Lime Down

Solar Park

Change Application and Consultation Report (Change Application)

Document Reference: EXAM/9.40

Proposed Emergency Access to Fire Appliance to BESS

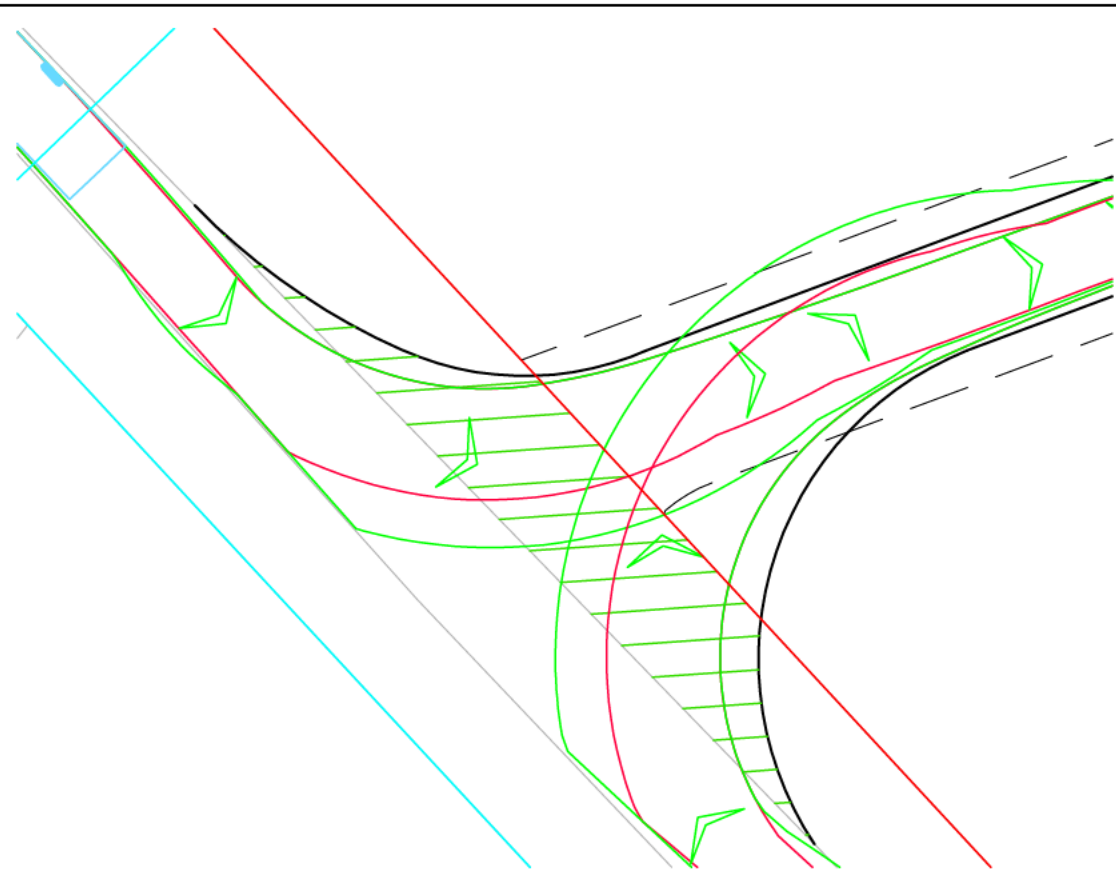
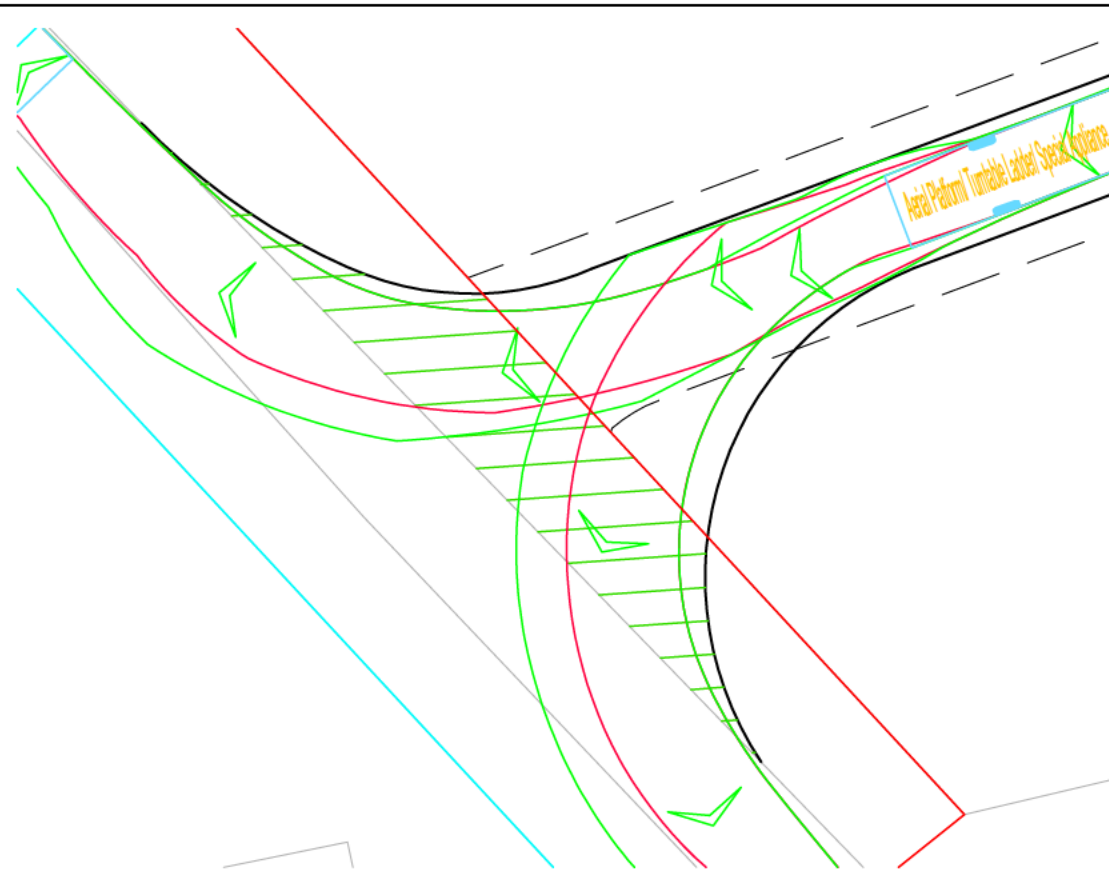
Because this change would add a small area of land to the Order Limits, it is classed as "additional land" under the relevant regulations. This means that, if the Change Application is accepted by the Examining Authority, there will be a statutory consultation on this change at a later date.

- Change 1 Location – which shows the location of the change described above.
- Drawing No. 2306-020_PL215-A Proposed Emergency Access to Fire Appliance to BESS – which provides a technical drawing of Change 1.
